Project	IEEE 802.16 Broadband Wireless Access Working Group < http://ieee802.org/16 >	
Title	Security Association Establishment for PKMv2-EAP	
Date Submitted	2004-08-29	
Source(s)	Mi-young Yun Jung-mo Moon Chulsik Yoon Young-jin Kim, ETRI 161, Gajeong-dong, Yuseong-Gu, Daejeon, 305-350, Korea	Voice: +82-42-860-4821 Fax: +82-42-861-1966 myyun@etri.re.kr
Re:	Contribution to P802.16e/D4	
Abstract	We propose to add and modify the EAP authentication and key distribution mechanism in the current TGe document on the basis of PKMv2-EAP mechanism.	
Purpose	Adoption	
Notice	This document has been prepared to assist IEEE 802.16. It is offered as a basis for discussion and is not binding on the contributing individual(s) or organization(s). The material in this document is subject to change in form and content after further study. The contributor(s) reserve(s) the right to add, amend or withdraw material contained herein.

Security Association Establishment for PKMv2-EAP

Mi-young Yun, Jung-mo Moon, Chulsik Yoon, Young-jin Kim

Figure 5. Proposed PKMv2-EAP-only mode authentication

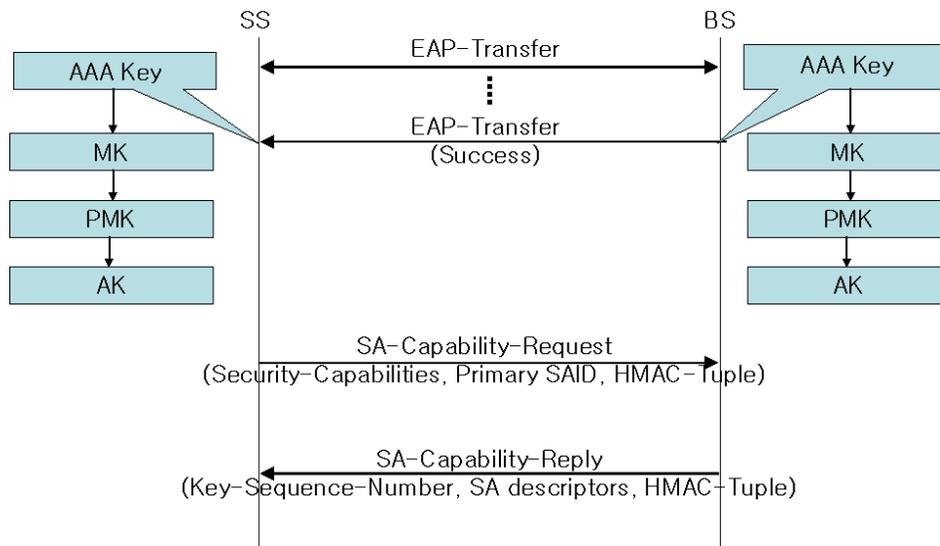
The proposed EAP-only mode authentication flow with SA-Capability messages is shown in Figure 5. The SA-Capability negotiation flow is shown in Figure 6 when the pre-authentication is used.

Accordingly, we define SA-Capability-Request and SA-Capability-Reply messages which can be validated by HMAC Tuple.
